RE: Request for Information #2 for File No. SUB21-008 – Koneru Short Plat  
6610 East Mercer Way, Mercer Island, WA 98040; King County Tax Parcel # 302405-9153

The City of Mercer Island reviewed your second submittal for SUB21-008. Following the review of the materials, City staff has determined that additional information is necessary to ensure compliance with the Mercer Island City Code (MICC). The following items will need to be addressed at your next submittal:

# KONERU SHORT PLAT, SUB21-008

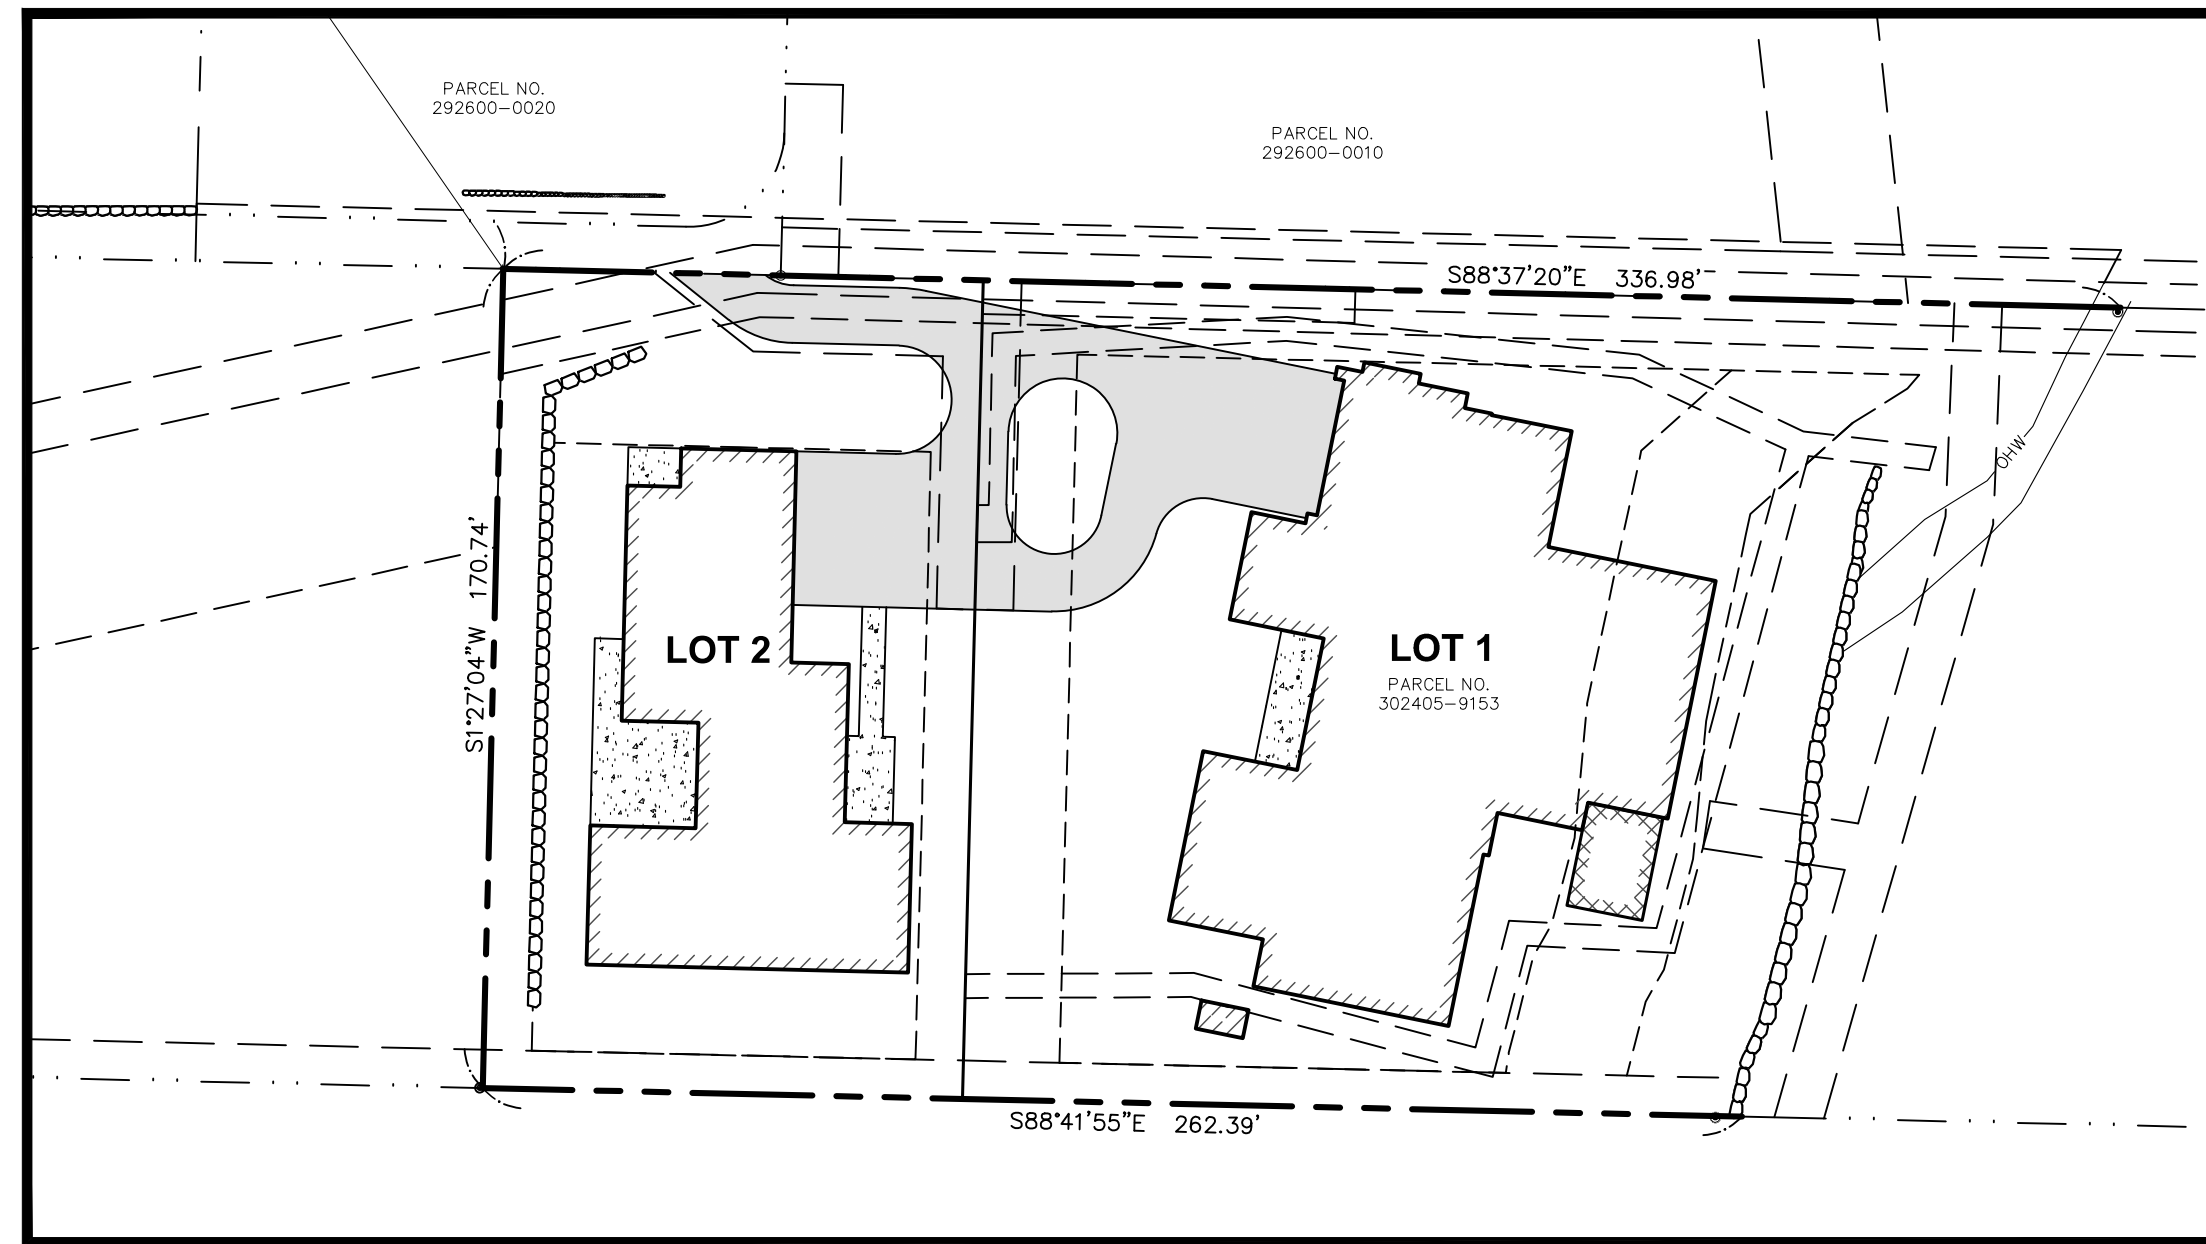
Therefore, we agree with the statement on the cover sheet of the plans. ***“This request does not guarantee that the lots will be suitable for development now or in the future.”***

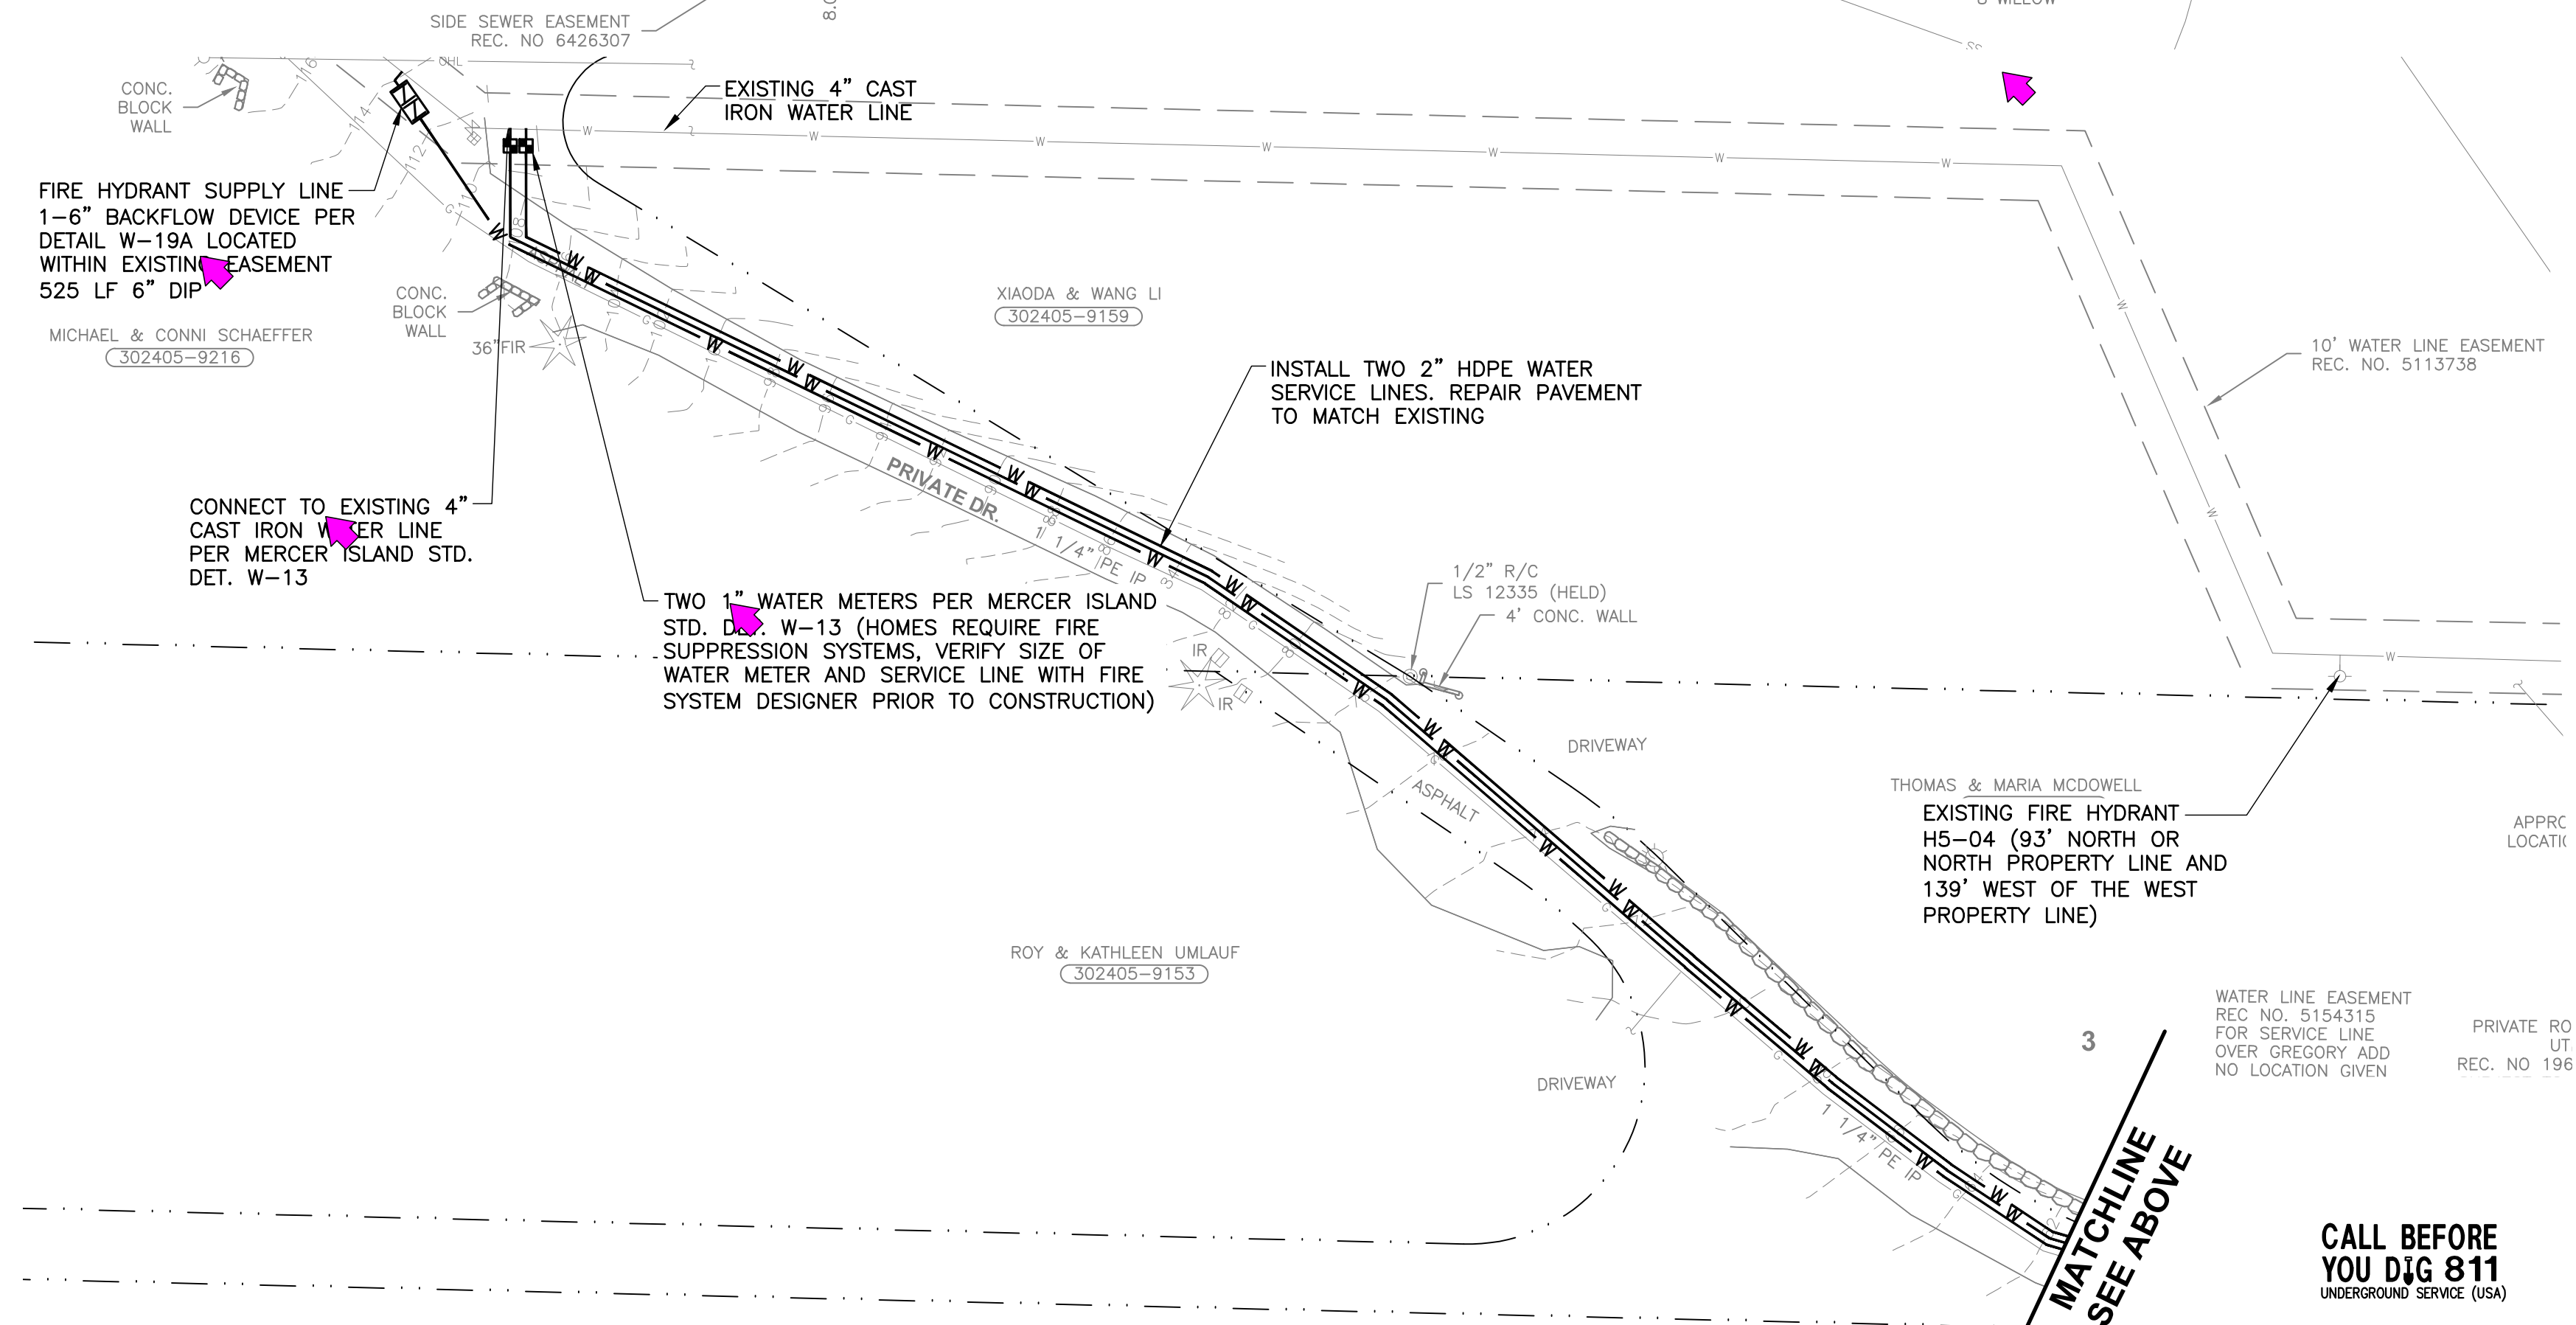
5. Future Building Permits:
  - a. For Civil and Arborist) During building plan review a tree protection plan with all Civil information must be created. Tree protection will need to be shown on C3.0. The retaining wall, trench, and other utilities to be moved outside saved trees driplines/minimum limits of allowable disturbance. The SD is shown within 9-feet of exceptional tree 576. Tree 575 also has a SD line within minimum limits of allowable disturbance. Update tree protection plan with tree protection chain link fence and all the following items in this checklist. Exceptional trees must be retained according to 19.10.060.3, and protected under 19.10.080.
